| Number | Description |
|--------|--|
| 1 | Wage Rates, BidItems, Revised or Added Plan Sht. Nos. 2, 14, 19, 23-29, 31, 33, 35, 36, 37, & 39; Amendment EBS Download Required. |
| 2 | BidItems; Revised or Added Plan Sht. Nos. 2, 3, 16, & 2003-2008; Amendment EBS Download Required. |

Intersection Improvements on SR 53 at Canal Road and County Farm Road, known as Federal Aid Project No. HSIP-0064-01(029) / 105293301 in Harrison County.

ADDENDUM

|  | C.L.B. | BY | MISSISSIPPI DEPARTMENT OF TRANSPORTATION SUMMARY OF QUANTITIES HWY. 53 |  WORKING NUMBER SQS-3 SHEET NUMBER 16 |

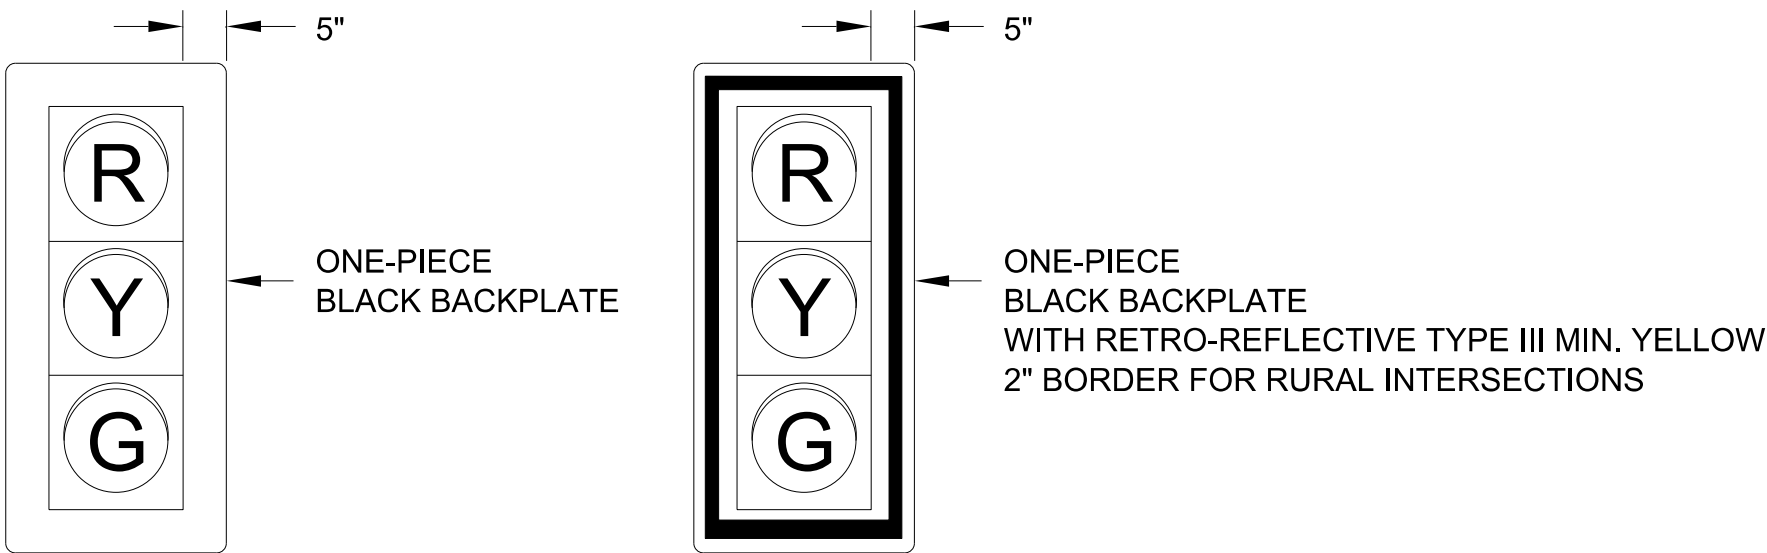
| | 1/15/15 REUSED PAI ITEMS & SHIFTED FOOTING LABELS. | REVISION | | |
